Ministry of Energy and Mines  
British Columbia

Synthesis and Analysis of Submissions  
to the Chief Inspector's Orders

Project Management, Engagement and  
Geotechnical Review of Dam Safety  
Inspections in BC

H348238-0000-15-124-0001

**Figure 3: Highest dam consequence classification status for studied Tailings Storage Facilities (TSF)**

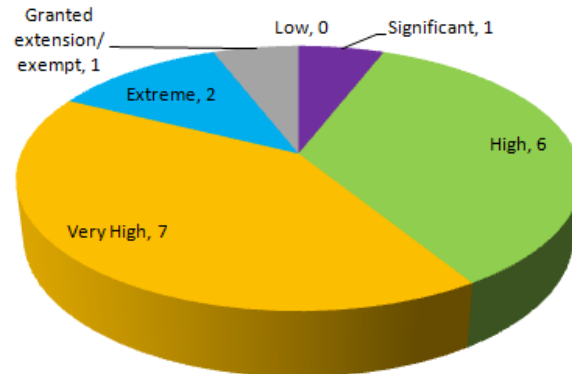
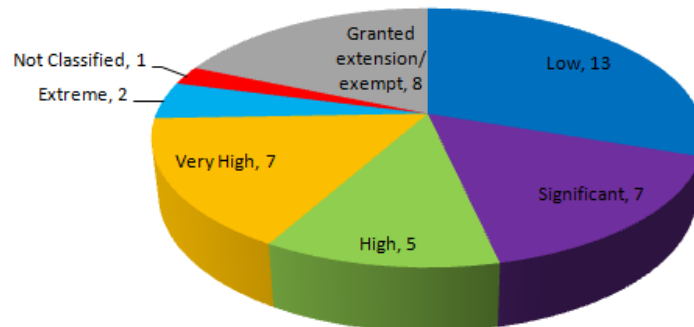
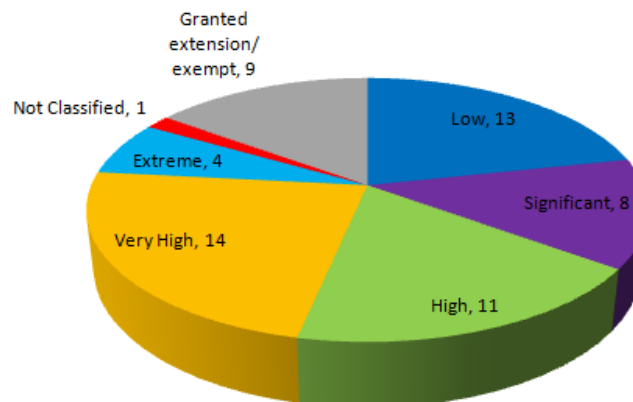
Table 4-4 and Figure 3 shows the distribution dam consequence classifications for all TSFs as noted on the 2014 DSIs. Of the total 60 mines, 9 were exempted or granted extension, 21 of the mines have a TSF with consequence classification of Low to Significant, and 29 mines have a TSF with consequence classification of High to Extreme (dam classification for one mine is still under review).

Figure 4: Compliance status for 60 permitted mines, by report type

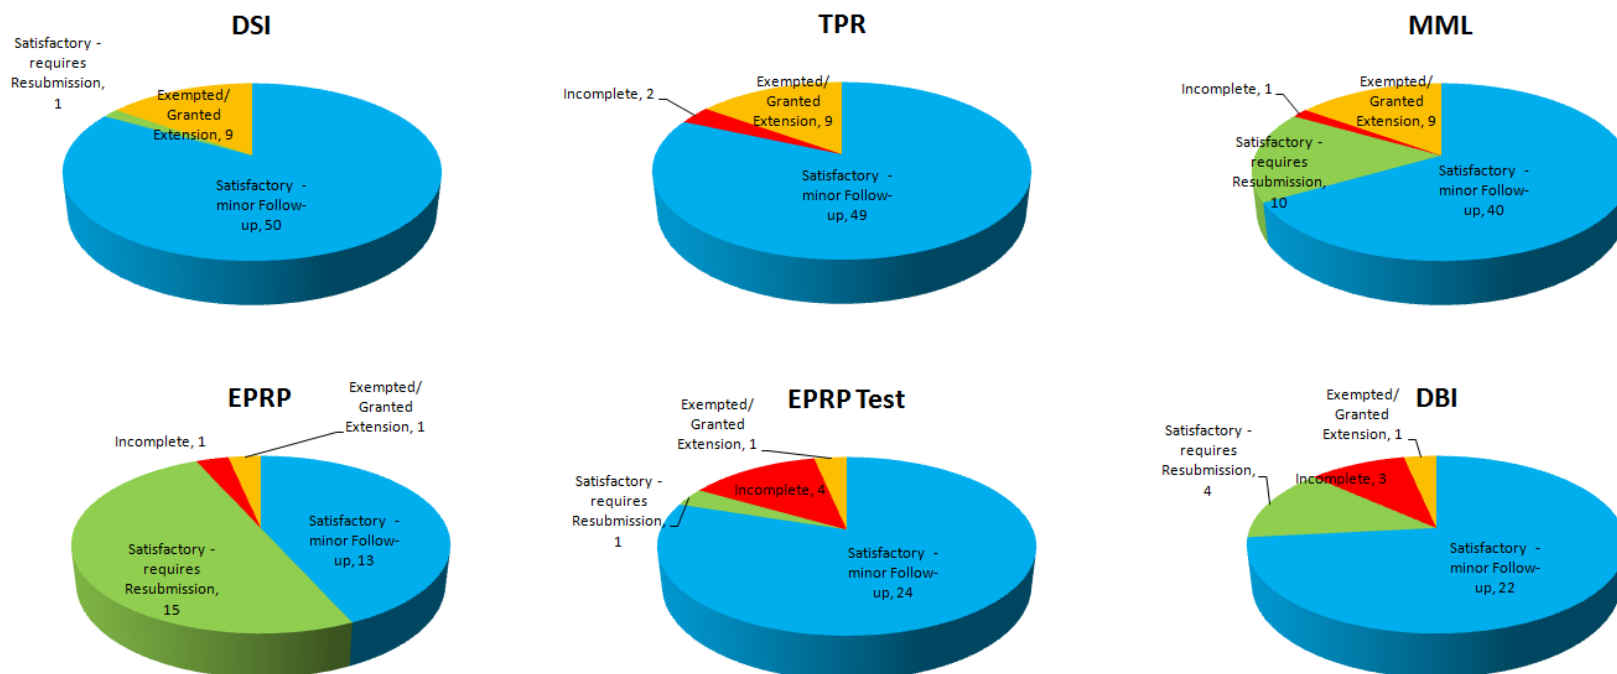
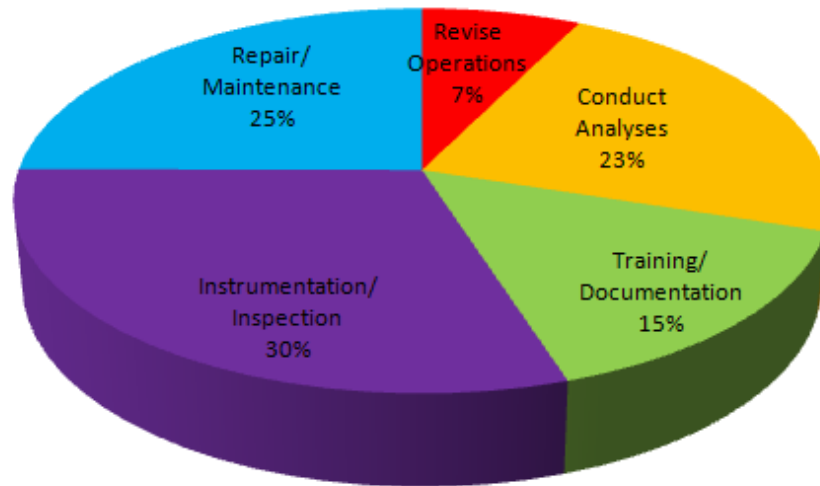
Table 4-7 and Figure 4 summarize the compliance status assigned based on the high-level review of the submissions. The data shows that the majority of the submissions were of good quality and have followed MEM and CDA guidelines. Follow-up letters have been issued by the Chief Inspector of Mines to all permitted mines under this Order with a list of any deficiencies and the timeline to address them. Table 4-7 shows a summary of the compliance status for different submissions.
